Hocutt-Ellington Library Renovation

Bid # 700-ENG-2025-12

Addendum No. 02

**A2** SINGLE RESTROOM ELEVATION  
3/8" = 1'-0"

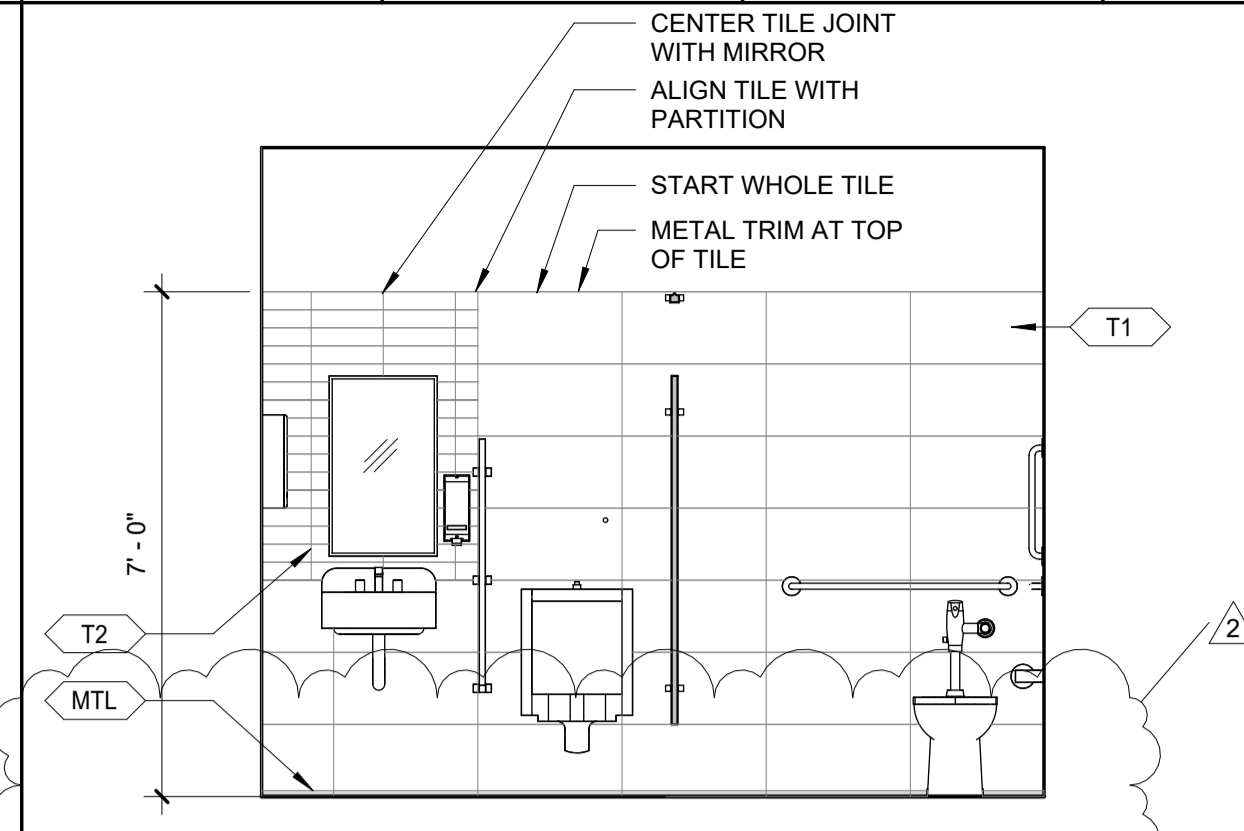
1. Sheet A400
  - a. Revised Restroom Elevations G4, G6, and A2 to remove the bullnose tile base (TB1) and instead indicate a metal transition trim.
2. Sheet A610
  - a. Added detail A6 to indicate the floor base treatment in restrooms for walls that do not have tile.
3. Sheet I100
  - a. Removed signage tag "ST-F" from the children's room area.
4. Sheet ED201
  - a. Clarifications for fire alarm system scope.
5. Sheet E201
  - a. Clarifications for access control, intrusion alarm and security panels, devices, and wiring.
6. Sheet E202
  - a. Clarifications for access control, intrusion alarm and security panels, devices, and wiring.

**G4** MEN'S RESTROOM ELEVATION  
3/8" = 1'-0"

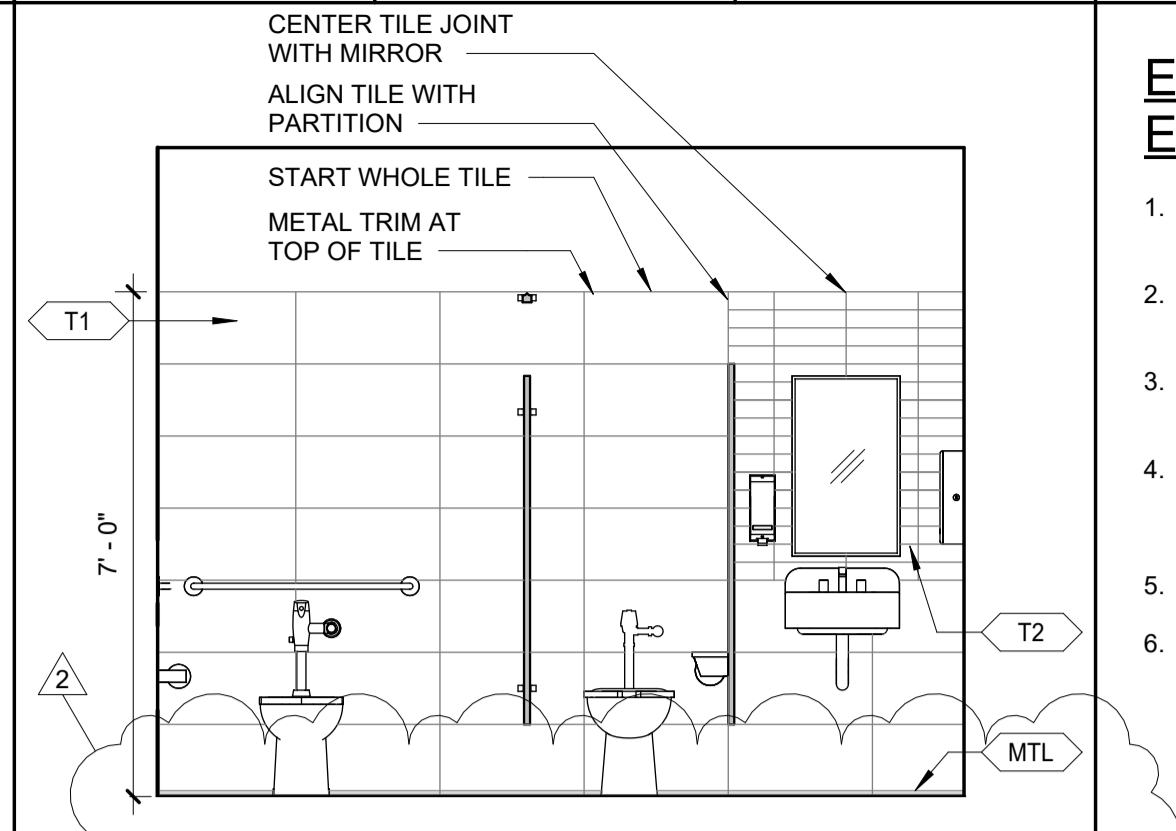
1. Per RFI#6 answer, they want metal cove trim in lieu of cove base. However, the Dilex-HKS has 2 anchoring sides so that can be used where wall tile meets the floor tile, but cannot be used at areas with no wall tile. Did they want wall tile throughout the room (elevations G4+G6 on A400 only indicate wet wall) – Otherwise, we will have to use the floor tile bullnose as the trim for the non-tile walls.

- a. **A revised detail for the walls not receiving tile has been developed. Refer to detail A6 on revised sheet A610.**
2. I was looking through addendum #1 and noticed they removed the tile base & replaced with Schluter Dilex. I am not understanding this since only the wet wall is getting wall tile according to sheet A400. Does this mean they are adding wall tile to all walls? You only use Schluter Dilex where floor & wall tile meet. Please advise if I should add wall tile to all walls or add tile base to walls not receiving wall tile.

- a. **Only the wet walls that are elevated on sheet A400 will receive full height wall tile. A new detail clarifying the non-tiled restroom walls has been added. Refer to detail A6/A610 and revised elevations on sheet A400.**

D1 FINISH PLAN  
1/8" = 1'-0"

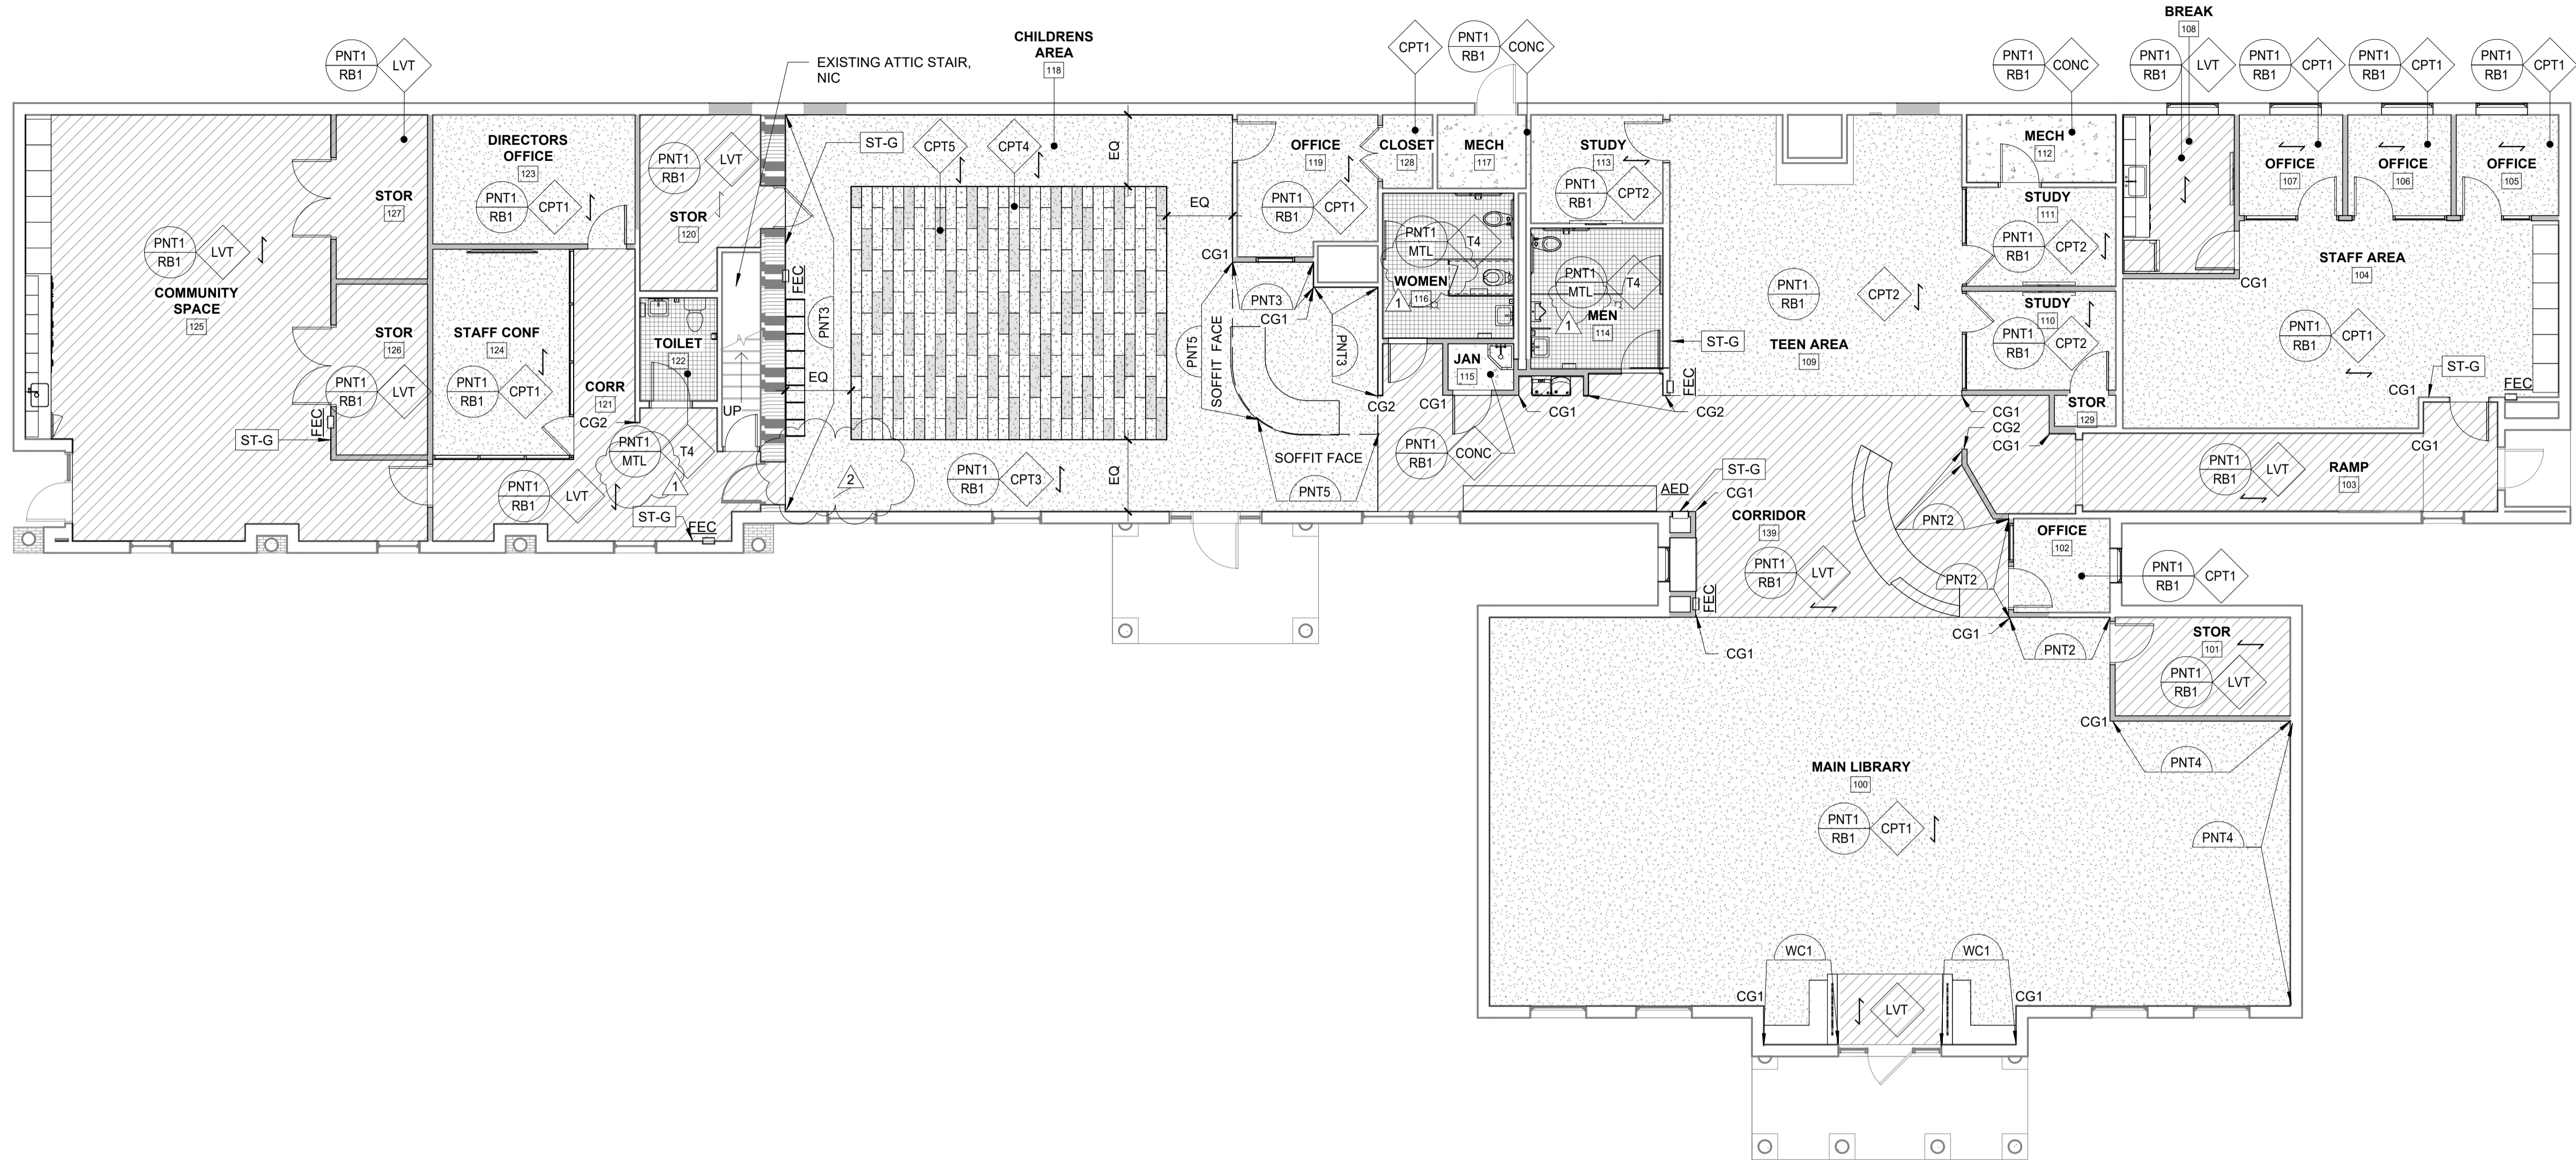
3. On sheet I-100 a sign type "ST-F" on D1/I100, but it is not detailed on the signage plan or drawing. Can you clarify what this sign is and its dimensions?

- a. **This was leftover from a previous sign type that is no longer within the project. This has been removed, refer to revised Sheet I100.**
4. 033000 1.7.A All installers and supervisors to be ACI Technician certified. This is mostly just a remove and pour back. Are these certifications needed?

1 FIRST FLOOR POWER PLAN - AREA A - DEMO WORK  
ED201 SCALE: 1/4" = 1'-0"

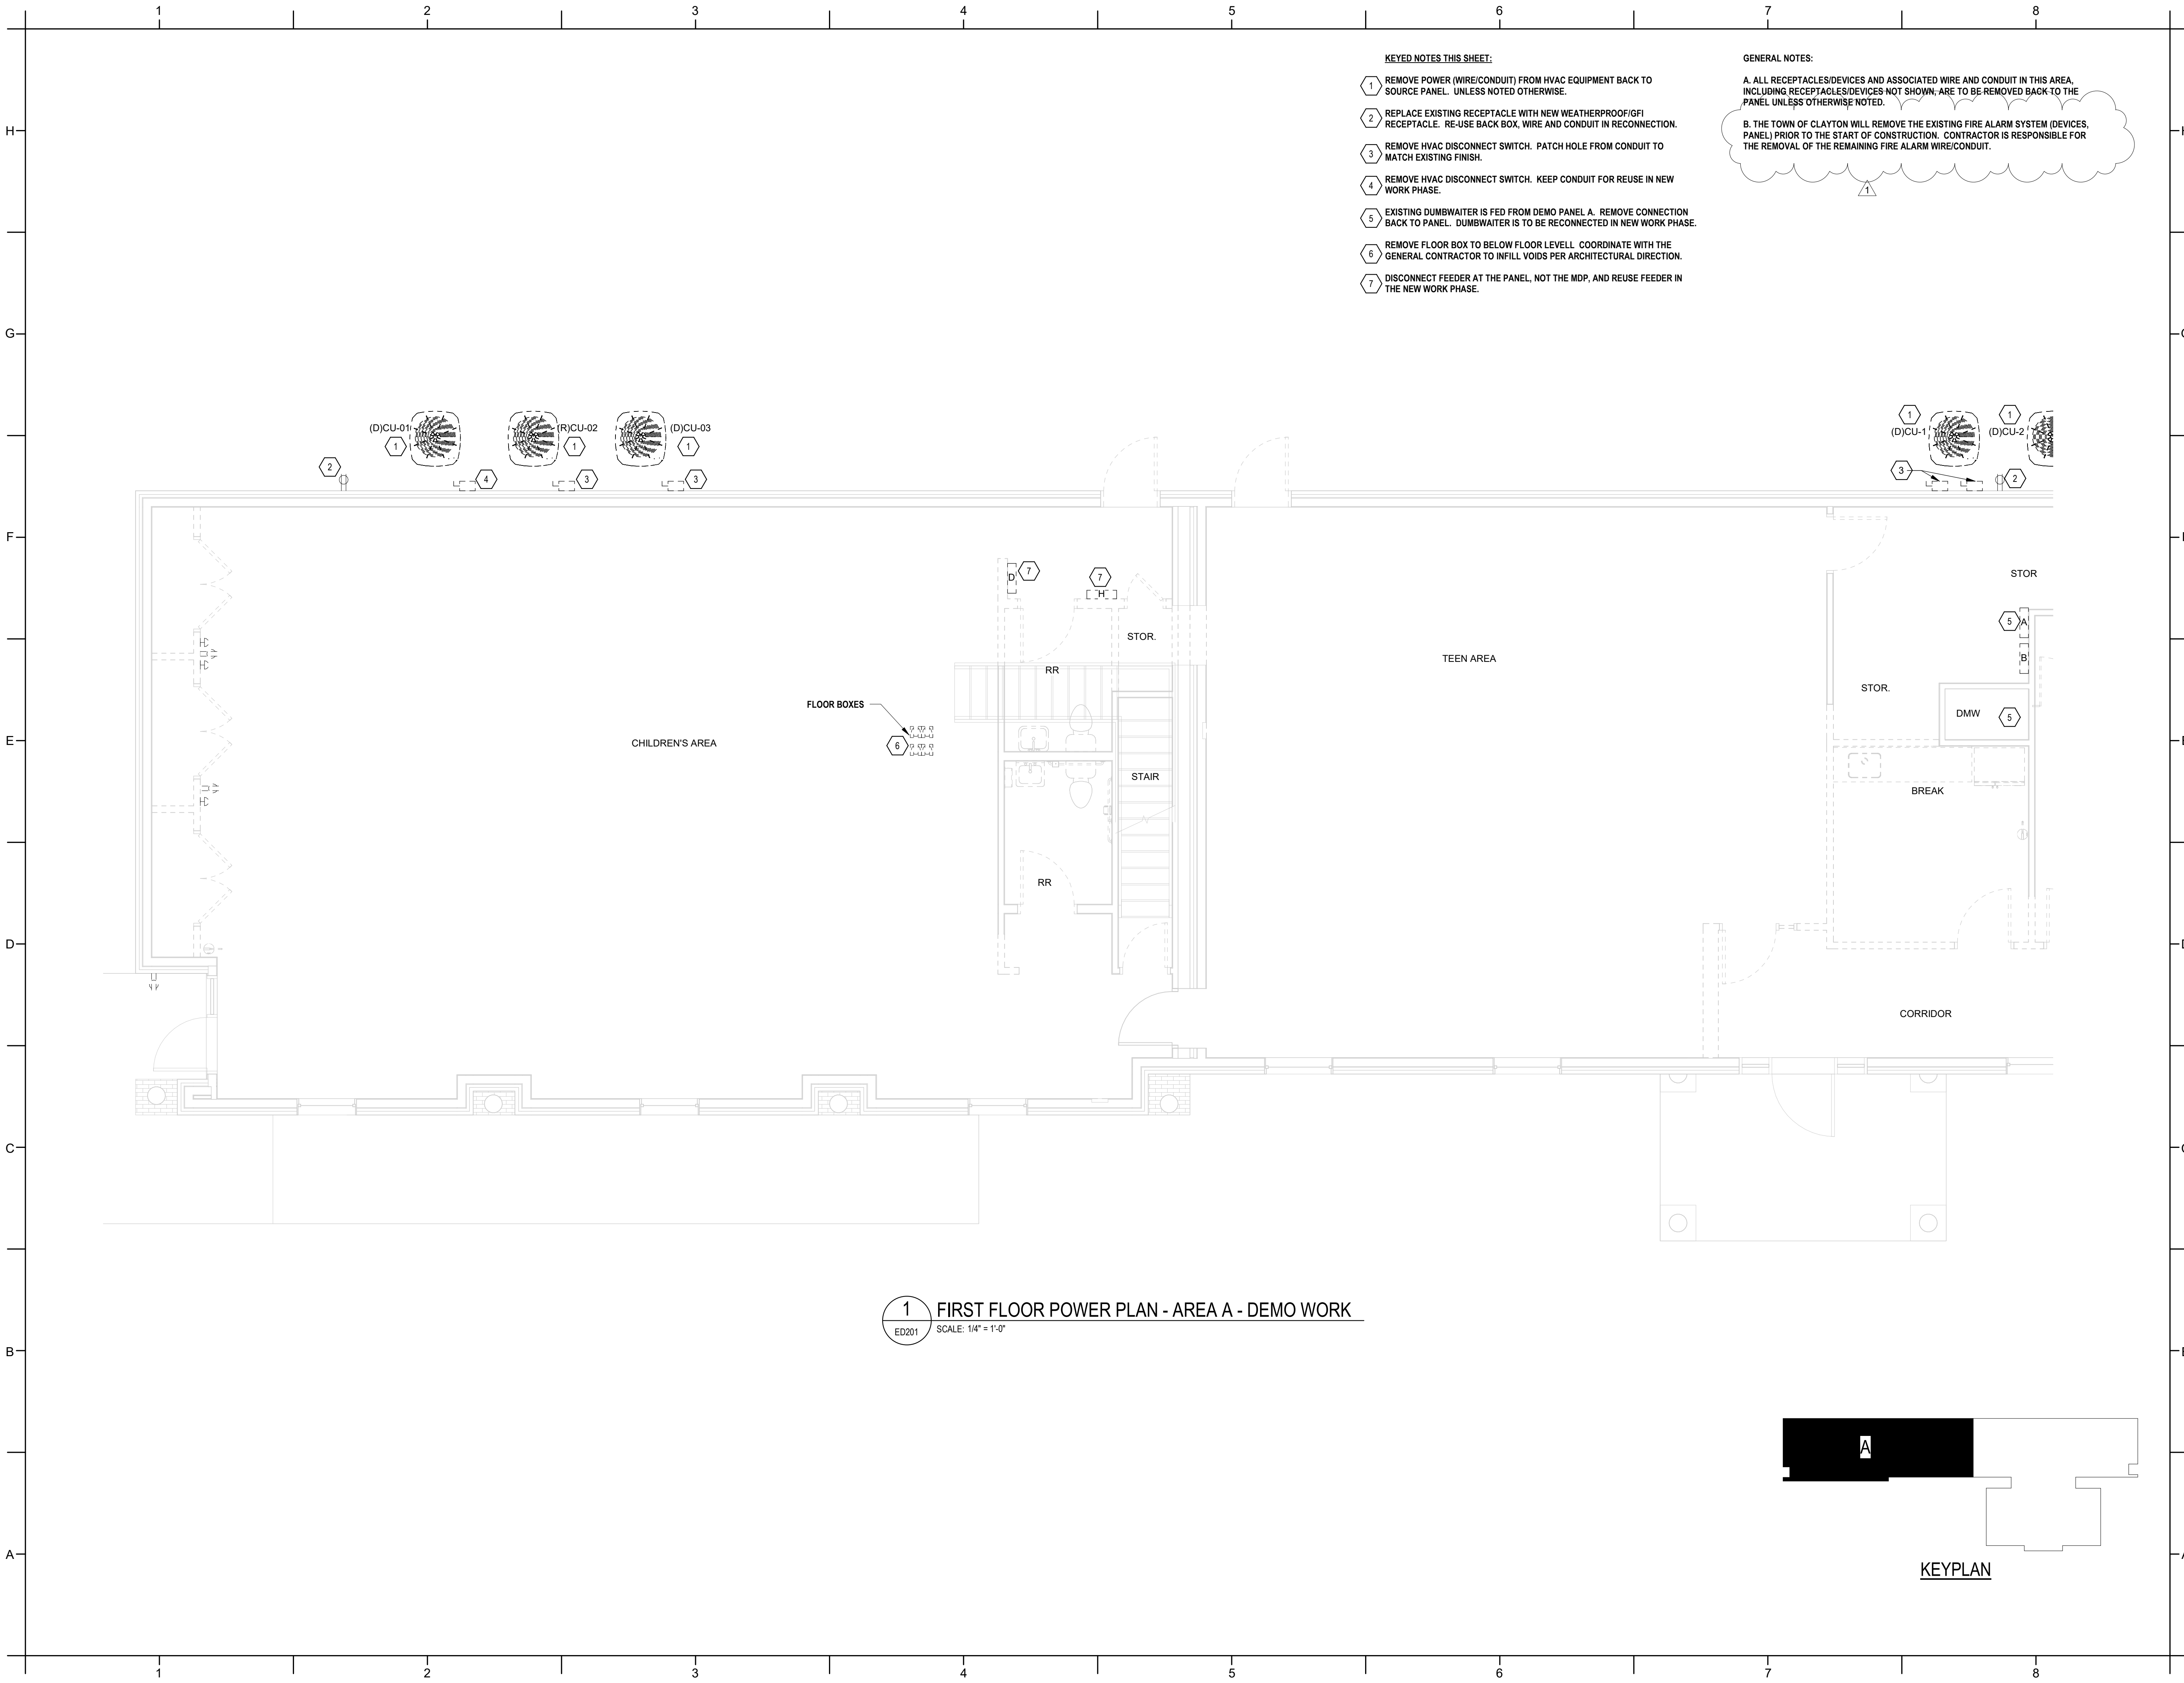
1. **Clarification: Regarding the fire alarm scope, the Owner will have the existing system removed prior to the GC taking over the library for renovation. The**

electrical drawings have been updated to communicate that the Owner will remove the existing fire alarm system before the GC takes over the building.

B. THE TOWN OF CLAYTON WILL REMOVE THE EXISTING FIRE ALARM SYSTEM (DEVICES, PANEL) PRIOR TO THE START OF CONSTRUCTION. CONTRACTOR IS RESPONSIBLE FOR THE REMOVAL OF THE REMAINING FIRE ALARM WIRE/CONDUIT.
